# 1990 Corvette: Service Bulletin: Clutch Apply Plate Material Changed to Powdered Metal

**Subject:** CLUTCH APPLY PLATE MATERIAL CHANGED TO POWDERED METAL

**Model and Year:** 1990 ALL CARS, TRUCKS, VANS WITH 4L60 (700-R4) AUTOMATIC TRANSMISSION

**Bulletin Number:** 90-189-7A - (03/06/1990)

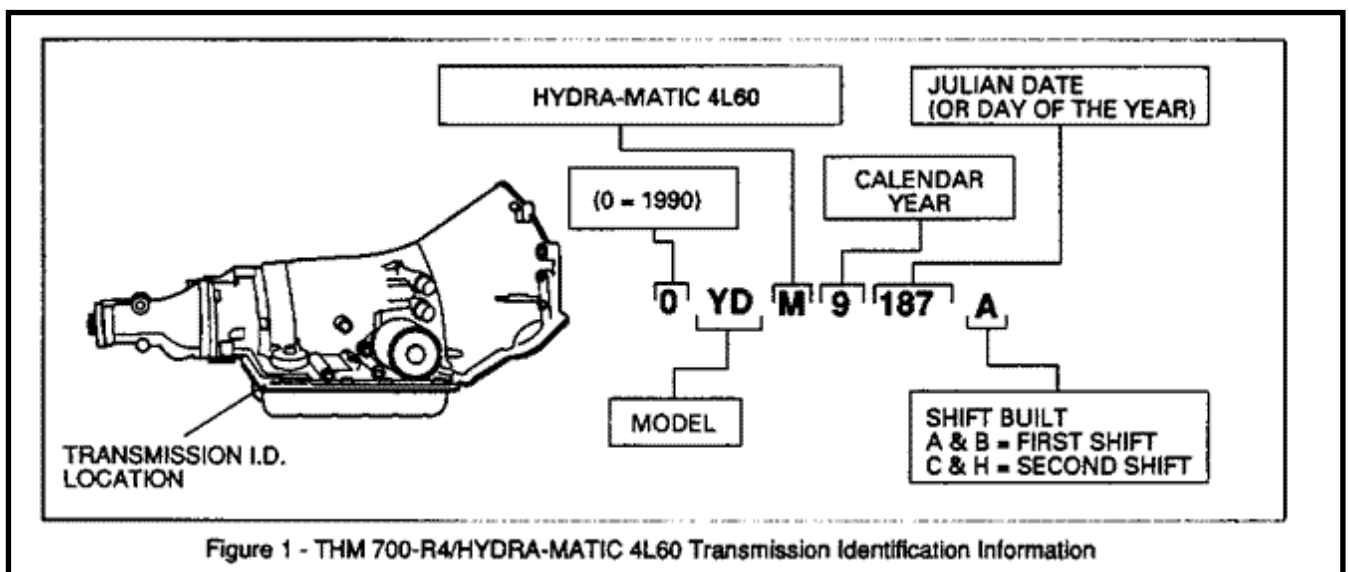
This bulletin covers a material change for the forward and 3-4 clutch apply plates. These clutches will now contain apply plates manufactured from powdered metal instead of steel.

The following dates show when changes went into effect: (Figure 1)

Forward January 25, 1990 (Julian Date 025)

3-4 January 29, 1990 (Julian Date 029)

The new powdered metal plates are interchangeable with the current steel plates. Dimensions of the new powdered metal plates are the same as the steel plates. Powdered metal plates will appear darker in color than previously produced steel plates.

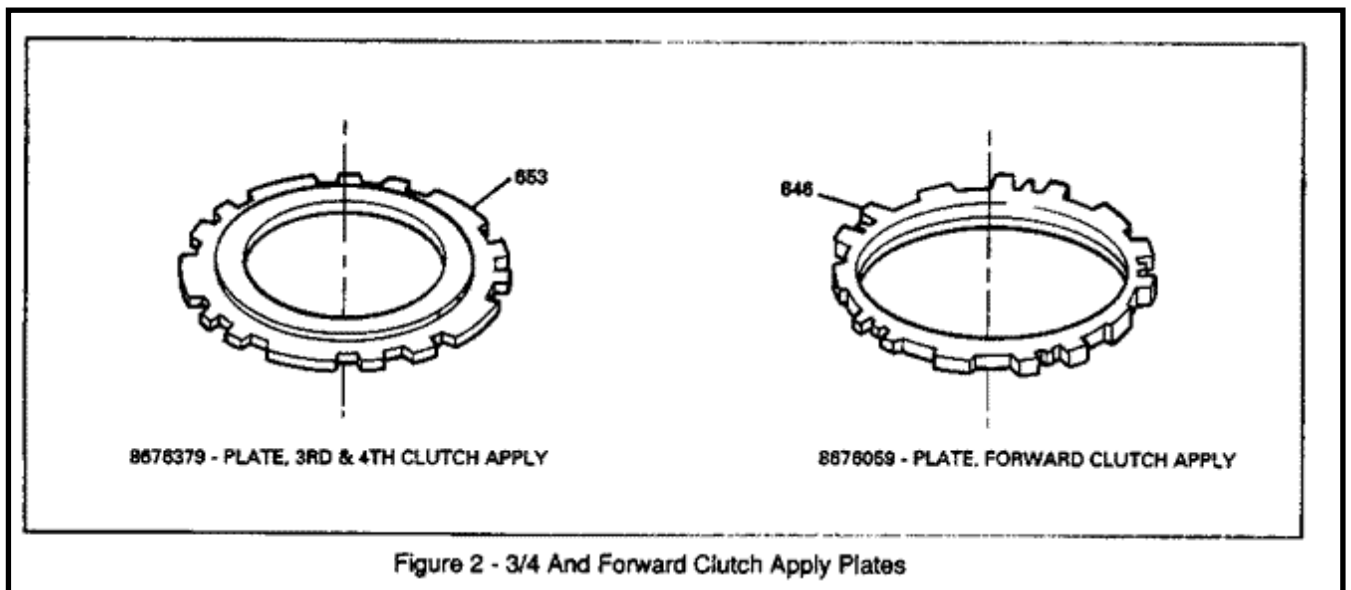
Part numbers have changed. (Figure 2)

8663785 Apply Plate - Forward Clutch (steel)

8667423 Apply Plate - 3-4 Clutch (steel)

8676059 Apply Plate - Forward Clutch (powdered metal)

8676379 Apply Plate - 3-4 Clutch (powdered metal)

When GMSPO stock of steel plates is used up, powdered metal plates will be available for service.
